Official Notification Federal Boat Safety Act Ring Gear Mounting Screws – 9.9 thru 25 Electric Start Models

Mercury and Mariner

1995 9.9, 15, 20, and 25 Electric Start Models

Figure 1. Flywheel, Ring Gear and Mounting Screws.

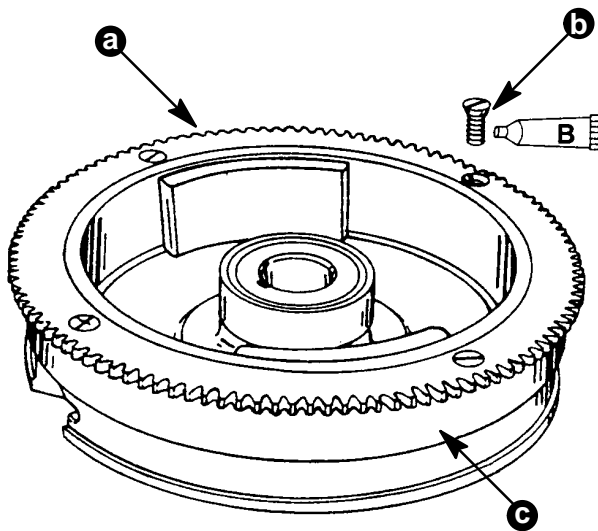
Flywheel ring gear mounting screws (Figure 1) may have been assembled with insufficient thread lock. Electric start outboards listed, require that the ring gear mounting screws be removed, liquid thread lock applied and the mounting screws replaced and re-torqued. Insufficient thread lock could allow the mounting screws to become loose and could cause the ring gear to become detached from the flywheel.

- a - Ring Gear
- b - Screw (4) Torque to 50 lb. in. (5.6 Nm)
- c - Flywheel

Loctite 271 (p/n 92-32609-1)

1. Disconnect battery cables.
2. Remove recoil starter and flywheel per appropriate service manual.
3. Remove 4 flywheel ring gear mounting screws.

4. Inspect and replace the ring gear P/N 43-99301 if the countersunk mounting screw holes appear distorted or if cracks are observed at the countersunk mounting screw holes. Note that distortion or cracks are unlikely if the mounting screws are tight.
5. Clean loose dirt from screws and flywheel and ring gear mounting holes.
6. Place one drop of Loctite 271 (p/n 92-32609-1) into each threaded ring gear mounting hole in the flywheel.
7. Torque the flywheel ring gear mounting screws to 50 lb. in. 5.6 (N.m).
8. Reassemble the flywheel and recoil starter assembly per appropriate service manual.
9. Reconnect battery cables.
